80-88 Regent Street, Redfern

Revised Response to Submissions

Figure 4: Ground level - 1.5m setback to Marian Street

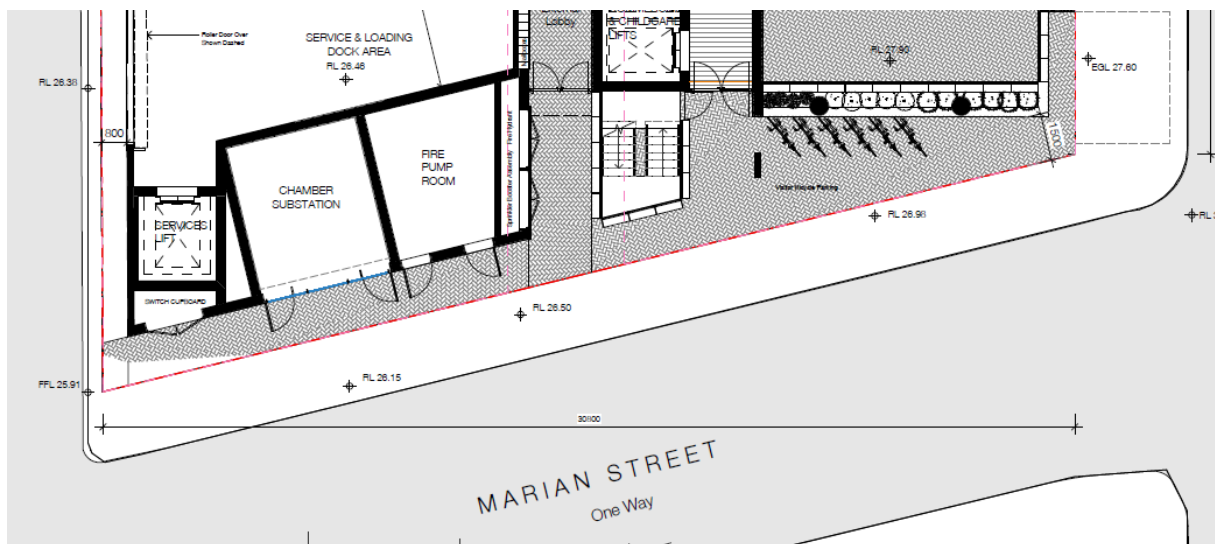
The street wall heights/tower setbacks and ground level setbacks of the proposal have been amended in response to the issues raised in the submissions as outlined below. The issues raised in relation to building separation are discussed in Section 4.3.

The ground level has been setback 1.5m from the Marian Street boundary consistent with the Draft UDPRC (refer to Figure 4 below). This aligns with setback and footpath along 7-9 Gibbons Street. The setback no longer tapers at the corner, but maintains the additional 1.5m for the extent of the Marian Street frontage.

The additional 1.5m setback provides an extension to the width of the existing footpath, however this section of the footpath will remain part of the site, and will not be dedicated to Council. This is consistent with the existing arrangement for the footpath widening in front of 7-9 Gibbons Street.

Levels 1, 2 and 3 have a zero setback to Marian Street, which cantilevers over the ground level by 1.5m. The zero setback is largely consistent with the setback of the previous RTS scheme, however two (2) of the residential levels have been replaced with commercial levels.

Figure 6: Tower setbacks to Regent Street – Level 4

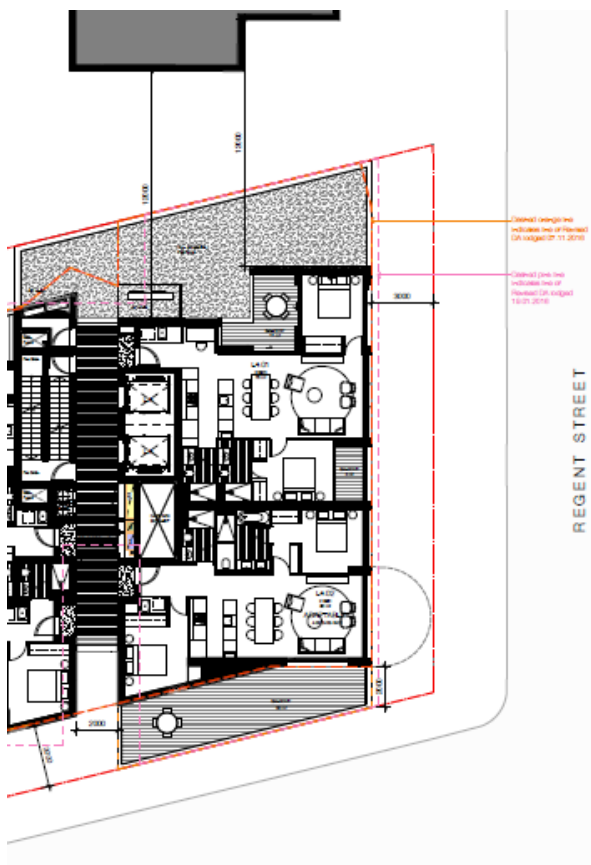
The earlier DA schemes (EIS and RTS August) encroached further into the street wall height with a variable setback to Regent Street ranging from 0m to 2.85m.

As illustrated in Figures 6 and 7, the current amended proposal provides a consistent 3m setback to Regent Street from levels 2 to 17, with the exception of a balcony encroachment, near the corner of Marian Street on Levels 5 to 17. This aligns with the 3m setback of the Iglu development.

Figure 8:: Street wall heights– Transition to 7-9 Gibbons Street

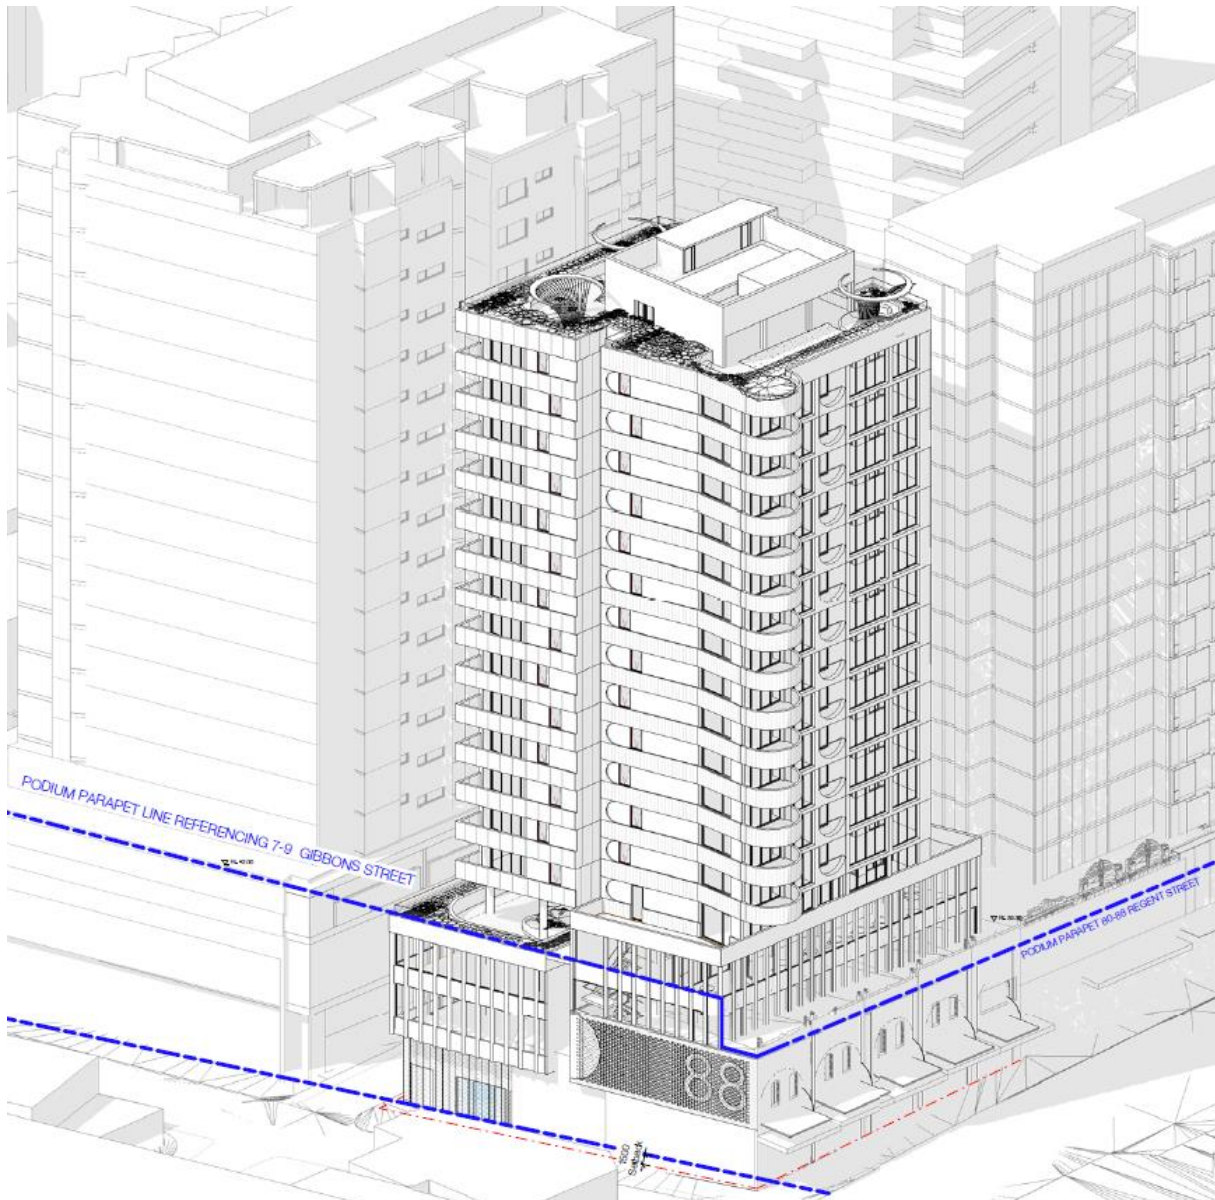
The height and massing of the podium to Marian Street has modified provide a clear transition between the two (2) storey street wall height on Regent Street and the podium height of 7-9 Gibbons Street on Marian Street.

- The proposal provides a three (3) to four (4) storey street wall height to Marian Street. As illustrated in Figure 8 the four (4) storey street wall height steps to a three (3) storeys towards the west, to align with street wall/podium height of 7-9 Gibbons Street. This step is attributed to the outdoor play area of the child care centre being located on the western side of level 3. This provides an appropriate transition between the two (2) storey street wall height on Regent Street and the three (3) to four (4) storey scale of the street wall/podiums on Marian Street;

Figure 9: Original (exhibited) tower and podium setbacks and the amended proposed setbacks on the right

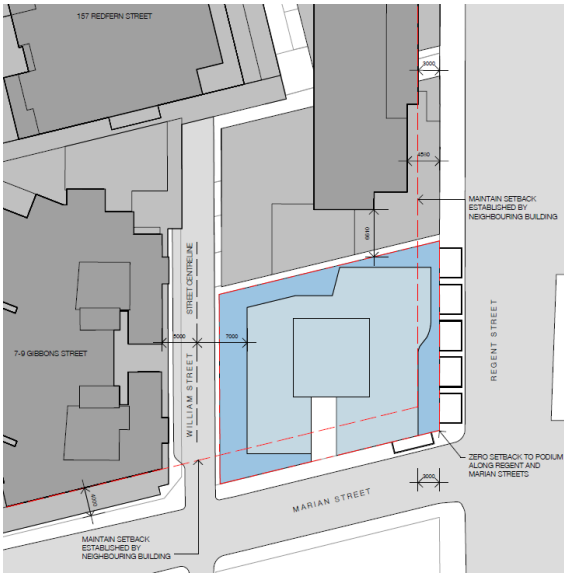
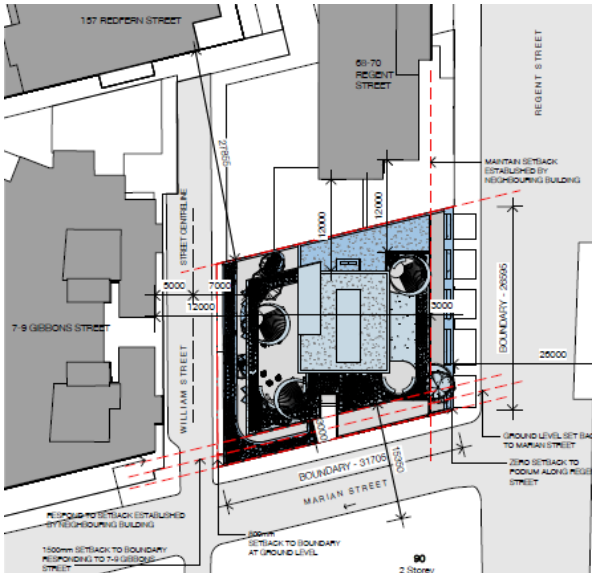
The previous scheme proposed a variable setback 0m to 3m to the northern boundary with the Iglu development from levels 2 to 17. This has been increased with the current proposal to provide a variable setback of 3m to 5m from levels 4 to 17. A zero setback is provided up to Level 3 with the introduction of non-residential uses on these levels. The increased setback creates a step in the northern façade of the proposal which aligns with the step in the southern façade of the Iglu building. This provides a 12m building separation between the buildings (Refer to Figures 9, 10 and 11).

Table 6 provides a comparison of the separation distances between the original DA (EIS) and the current amended proposal, which is illustrated in Figure 9.

Figure 14: View impacts from Level 18 – 157 Redfern Street

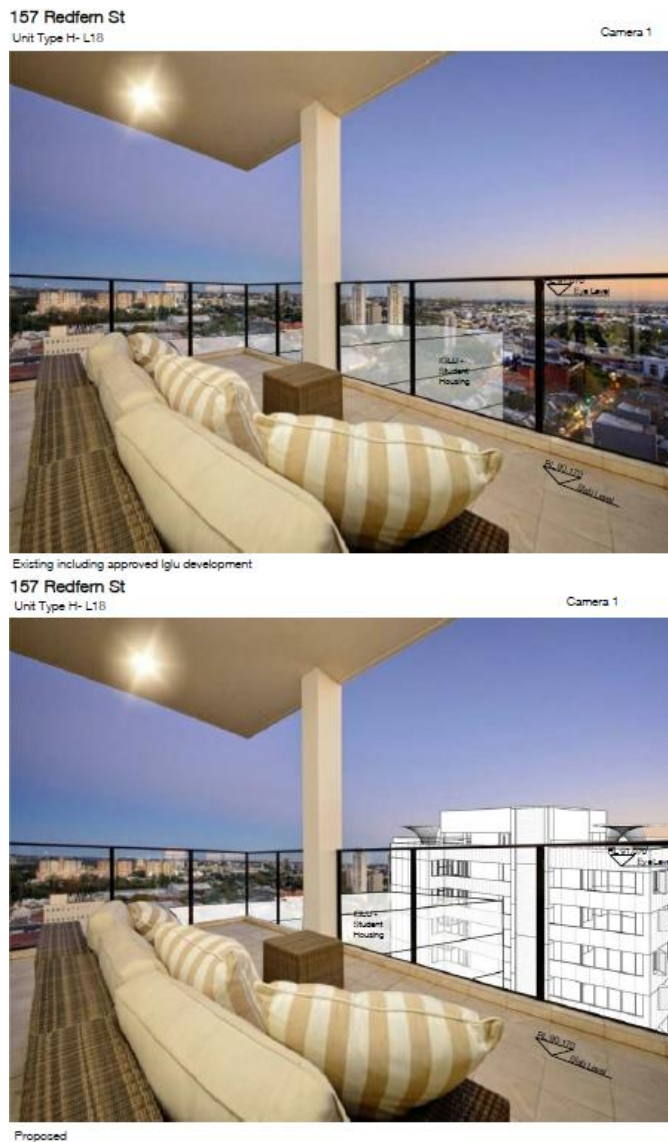
The proposal will have a severe impact on the outlook and district views towards the south from the balcony and living room of the 14 type 'B' apartments on Levels 5 to 18. The view impact analysis shows the impact from the uppermost apartment on Level 18 from the balcony of the view shown in Figure 14. It is expected that part of the outlook to the south from the 14 type 'B' apartments will be retained down the view corridor created by William Lane. This is not illustrated in the analysis as it has relied on photographs of views sourced from real estate agent sites. It can be expected that the impacts will be greater from the lower levels of the building, as Level 18 will retain glimpses of views around the proposal and over the adjoining Iglu development.

Figure 15: Partial views to the south will be retained from living rooms of 'Apartments C' at 7-9 Gibbons Street (image from level 14)

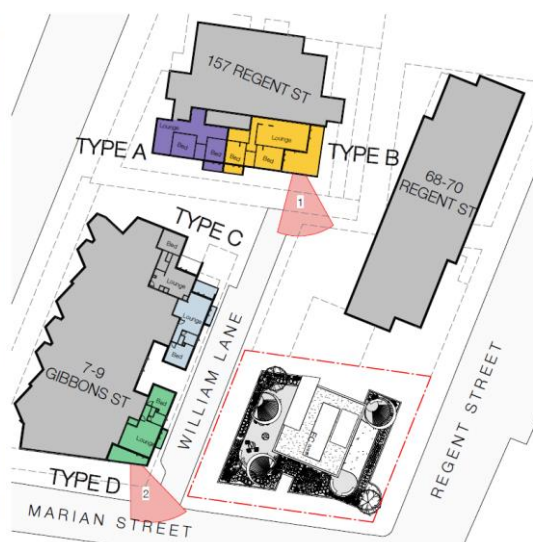
The 14 type 'C' apartments on Levels 4 to 17 will retain views to the east from their living room windows and balcony between the proposed building and the Iglu development. The increased northern boundary setback provides a larger view corridor between the proposal and the Iglu development and will reduce the impacts on views from 7-9 Gibbons Street. As illustrated in Figure 14, the separation between the buildings provides a view corridor that will ensure outlooks and districts views towards the eastern suburbs will be retained from the balcony and living room. Some views towards the south will also be retained from the living area (refer to Figure 15). The proposal will partially obscure views from the bedroom windows of the type 'C' apartments on Levels 4 to 17 (refer to Figure 16). Overall the impact on Apartments C on Levels 4-17 is considered to range from minor to moderate.

Figure 16: Partial view to the east will be retained from bedrooms of 'Apartments C' at 7-9 Gibbons Street (image from level 14)

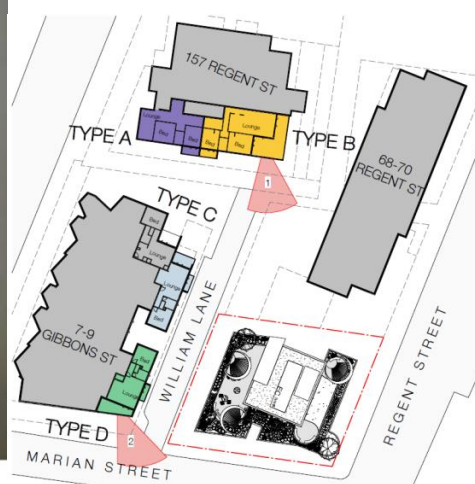
The separation distance to Iglu provides a view corridor to ensure the type 'C' apartments at 7-9 Gibbons Street will maintain their easterly views from their living room and balcony (refer to Figure 16). As a result, the variation to the northern boundary setback distances applying under the ADG does not have an unacceptable impact on the easterly views from 7-9 Gibbons Street.

Figure 17: Views to the south from the balconies and living rooms of 'Apartments D' at 7-9 Gibbons Street will not be impacted by the proposal (image from level 8)

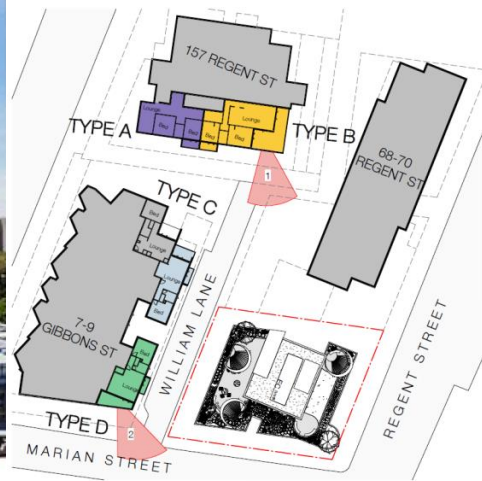
Views to the south from the living room and balcony of the 14 type 'D' apartments on Levels 4 to 17 will not be impacted by the proposal (refer to Figure 17). These apartments have a narrow, secondary balcony off the living room which has views to the east. The proposal will obscure views from this balcony and the balcony windows (refer to Figure 18). The views from the bedroom will also be obstructed. It is noted that these bedrooms have highlight windows, which is expected to limit the extent of the view that can be seen from the
